TECHNICAL EVALUATION REPORT
R. E. GINNA NUCLEAR POWER PLANT
STATION BLACKOUT EVALUATION

TAC No. 68548

Final
October 30, 1991

U.S. Nuclear Regulatory Commission
Washington, D.C. 20555

ROCHESTER GAS AND ELECTRIC CORPORATION
 A. E. GINNA NUCLEAR POWER PLANT
 UPDATED FINAL SAFETY ANALYSIS REPORT
 Figure 1
 Electrical Distribution System

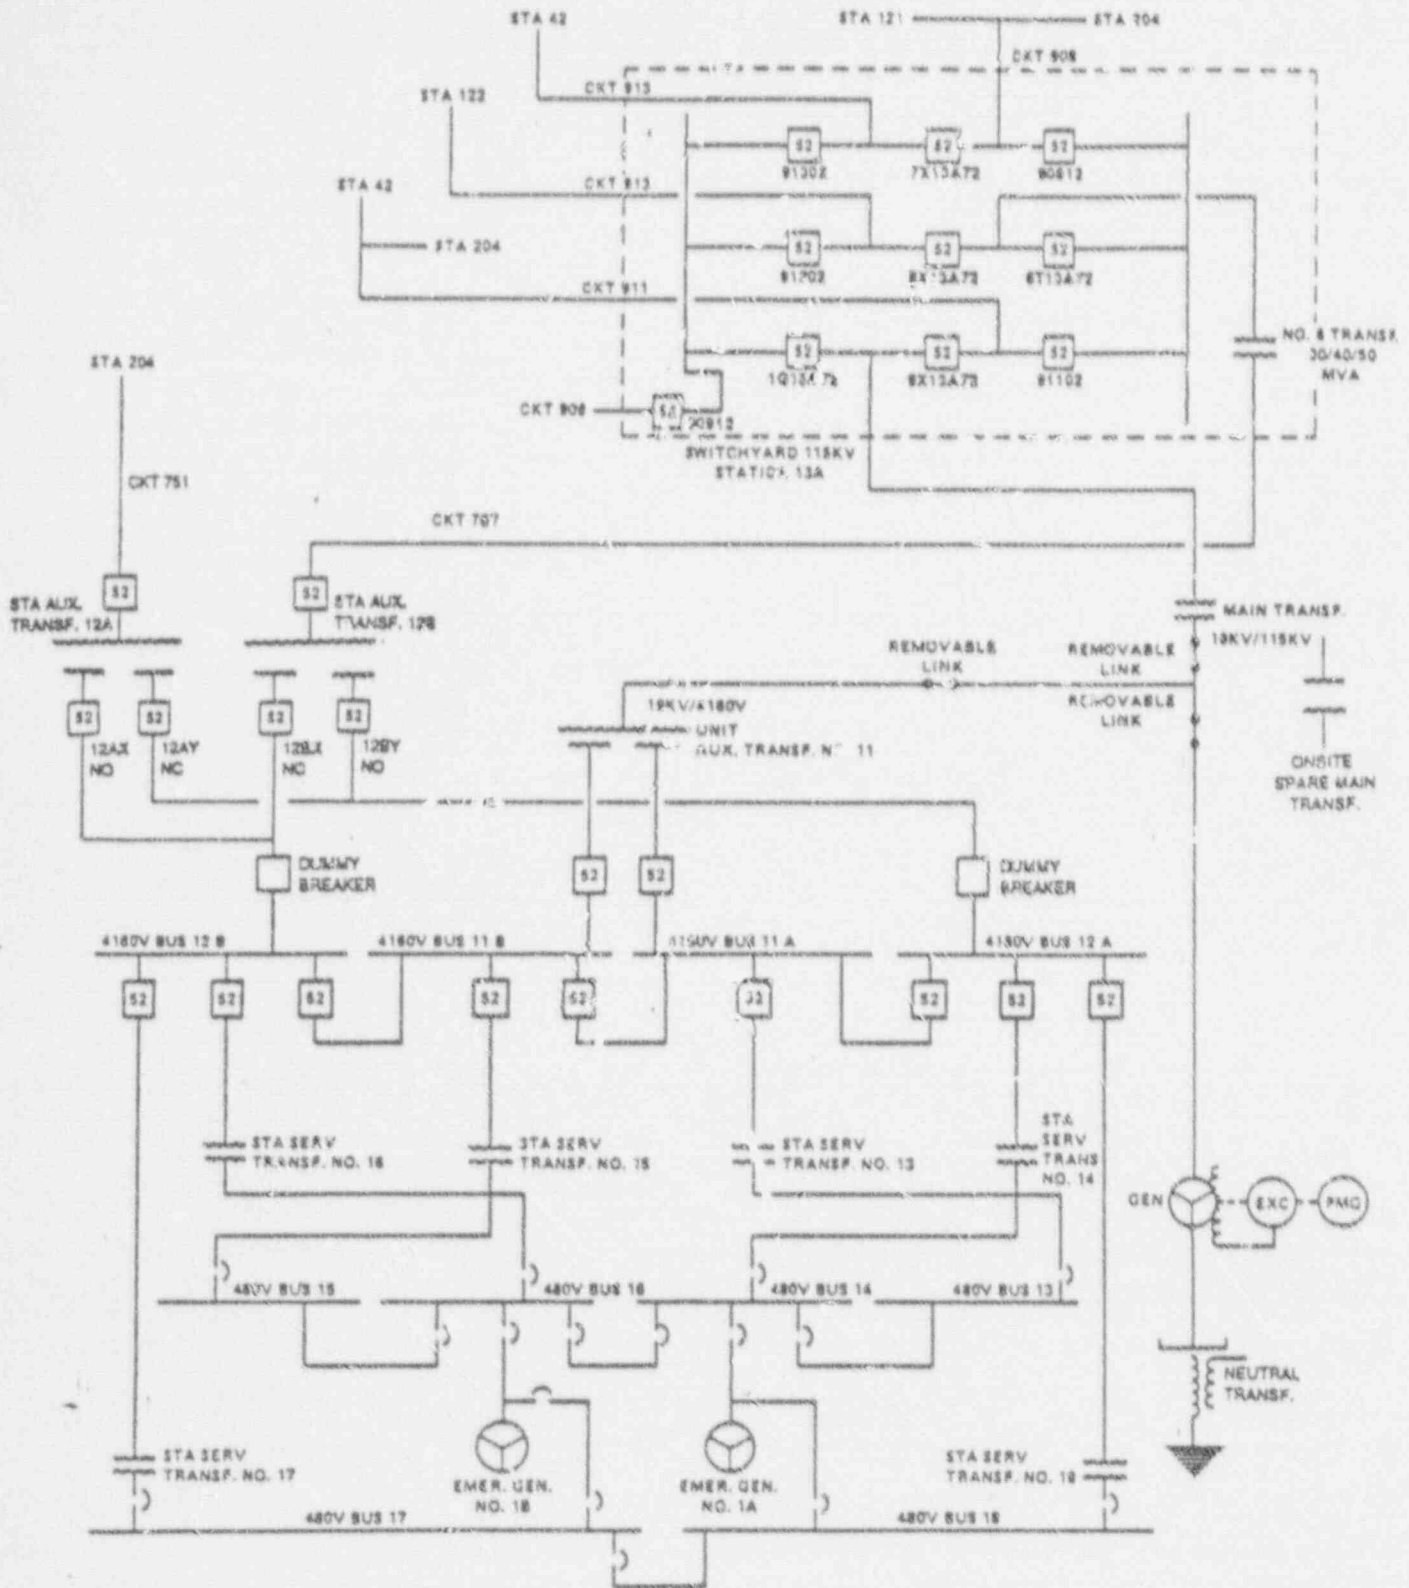
The licensee classified the independence of the plant offsite power system as "I1/2." Our review of the plant UFSAR indicates (16) that (see Figure 1):

1. All offsite power sources are connected to the plant through electrically connected switchyards,
2. The safeguard buses are normally powered from two offsite power sources through Station Auxiliary Transformers (SATs) 12A and 12B, (each division of safeguard buses is powered from one SAT),
3. Each SAT is sized to accept all plant auxiliary loads for full power operation, and
4. Upon loss of power from one SAT, the connected safeguard buses can be powered from the other SAT through manual transfer.

Based on the above and the criteria given in RG 1.155, Table 5, the Ginna offsite power characteristics is classified as "I2."
